Serial: RNP-RA/02-0066

H. B. ROBINSON STEAM ELECTRIC PLANT, UNIT NO. 2
DOCKET NO. 50-261/LICENSE NO. DPR-23

REQUEST FOR TECHNICAL SPECIFICATIONS
CHANGES TO INCREASE AUTHORIZED REACTOR POWER LEVEL

Figure 2.1.1-1 (page 1 of 1)
Reactor Core Safety Limits

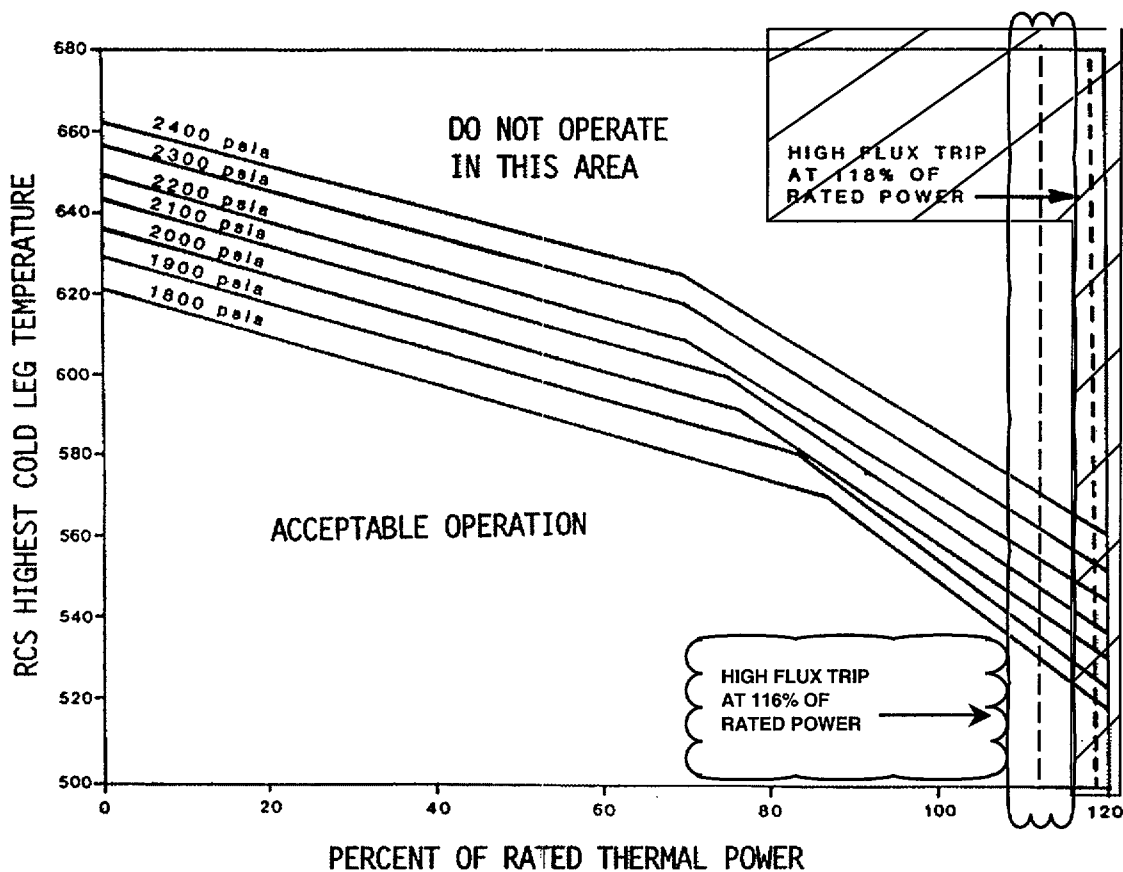
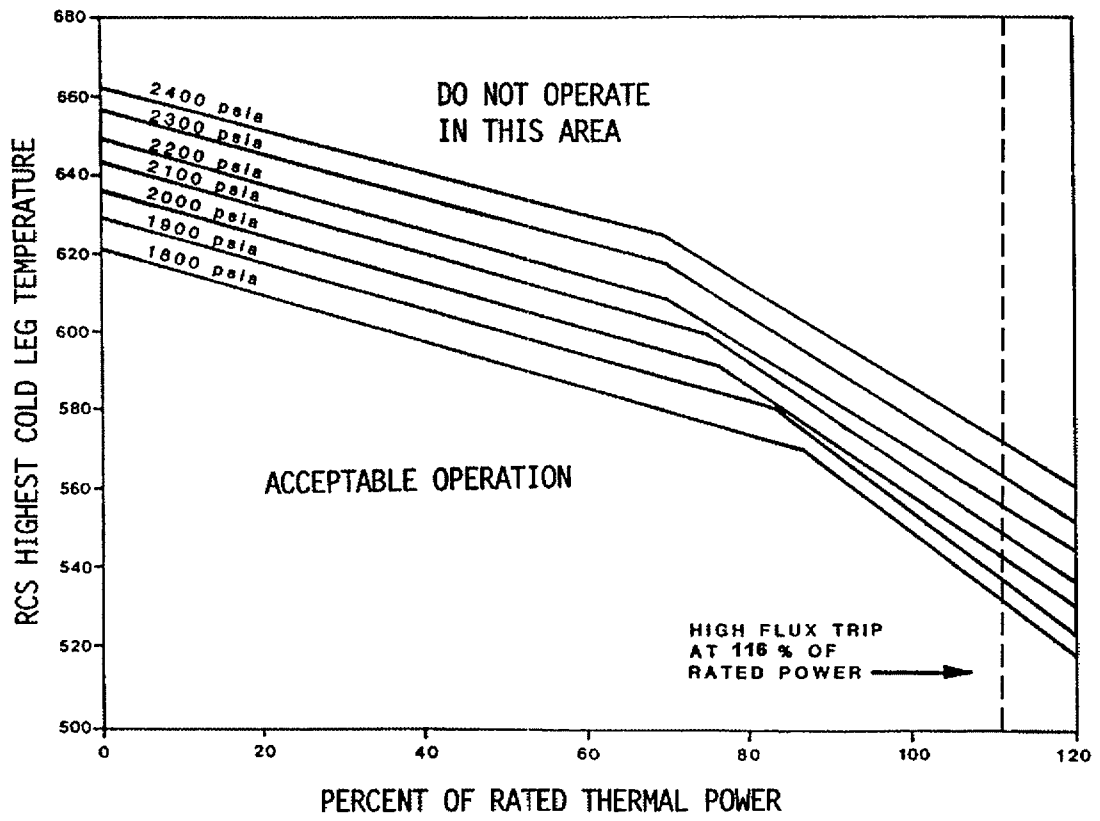
- The reactor core safety limit curve in TS 2.1.1, Figure 2.1.1-1, “Reactor Core Safety Limits,” indicates the High Flux Trip at 118 percent of rated thermal power. The indicated High Flux Trip will be changed to 116 percent of rated power.

As a result of this change in the analytical limit for the Power Range Neutron Flux Trip, the High Flux Trip indicated on TS Figure 2.1.1-1, "Reactor Core Safety Limits," will be revised from the current value of 118 percent of rated power to reflect the revised analytical value of 116 percent of rated power. This change will ensure that the overpower limits assumed in the thermal-hydraulic design analysis for the nuclear fuel are maintained.

Figure 3.4.3-1
 Reactor Coolant System Heatup Limits
 Applicable Up to 23.96 EFPY

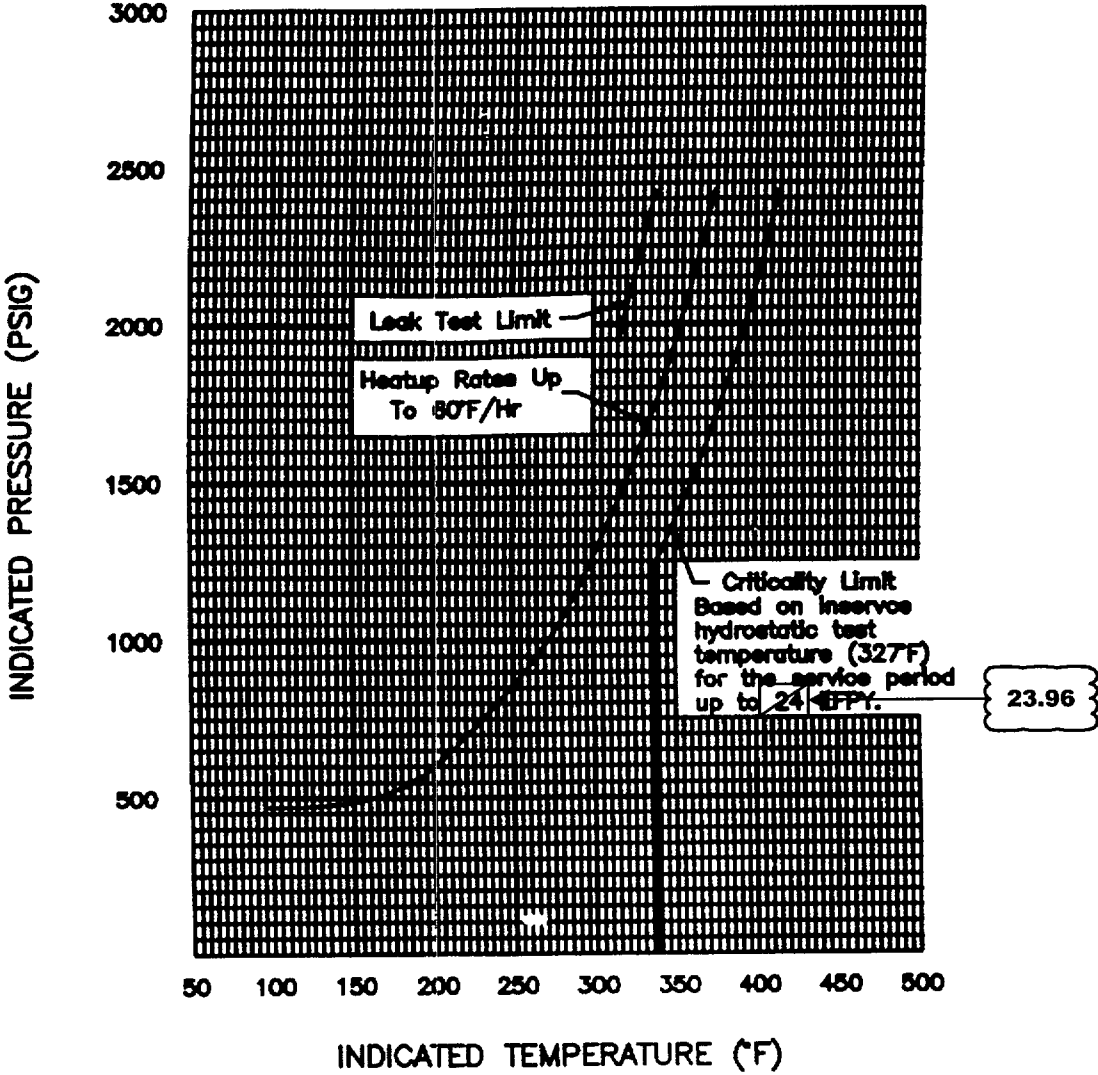
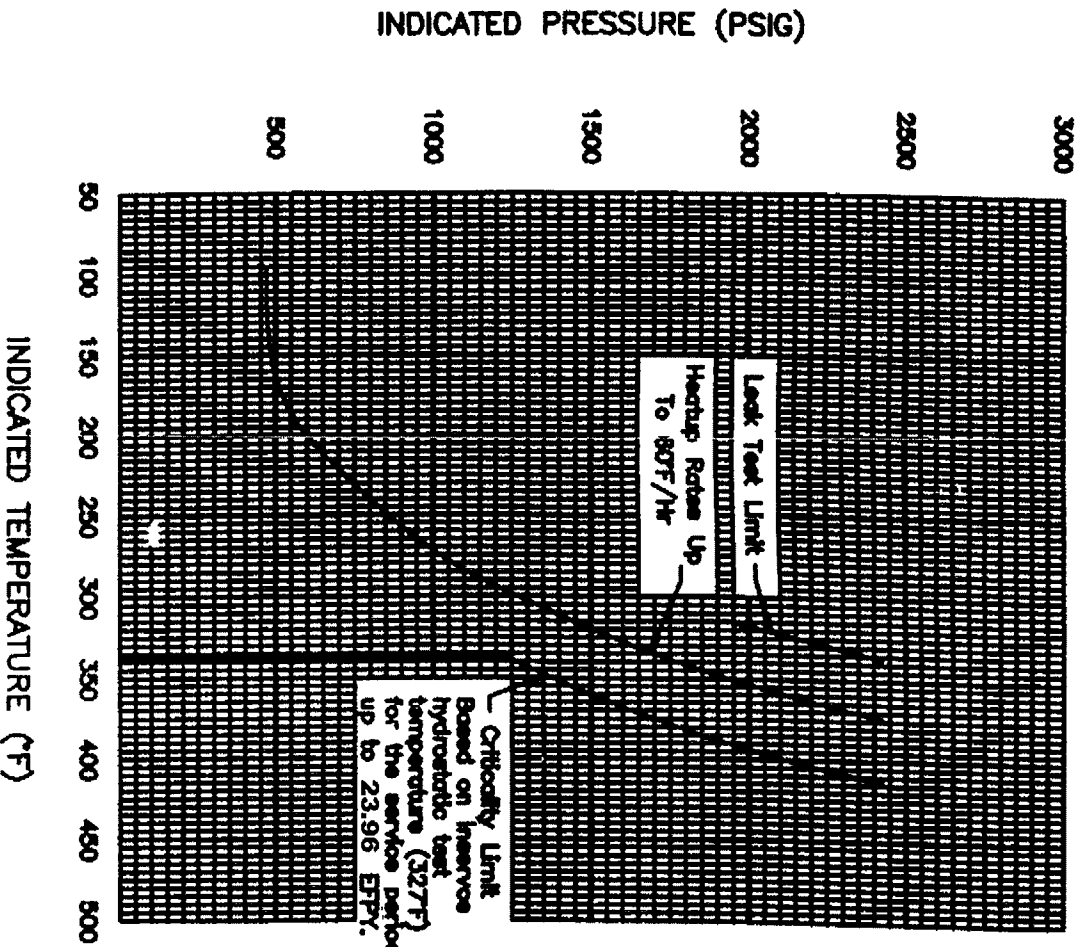
- The RCS pressure-temperature limit curves in TS 3.4.3, Figure 3.4.3-1, “Reactor Coolant System Heatup Limits Applicable Up to 24 EFPY,” and Figure 3.4.3-2, “Reactor Coolant System Cooldown Limitations Applicable Up to 24 EFPY,” are applicable through 24 effective full power years (EFPY) of operation. These figures will be revised to reflect applicability through 23.96 EFPY.

The 10 CFR 50, Appendix G, curves and reference temperature values will not change as a result of the power uprate. However, the RCS pressure-temperature limit curves of TS 3.4.3, Figures 3.4.3-1 and 3.4.3-2, will be re-designated from 24 effective full power years (EFPY) of operation to 23.96 EFPY to reflect a conservative projection of the increase in neutron fluence associated with the power uprate. This projection will ensure that the requirements of 10 CFR 50, Appendix G, "Fracture Toughness Requirements," will continue to be met following the proposed power uprate.

23.96

Curves applicable for heatup rates up to 80°F/hr for the service period up to 23.96 EFPY. Includes +10°F and -60 PSIG allowance for instrumentation error.
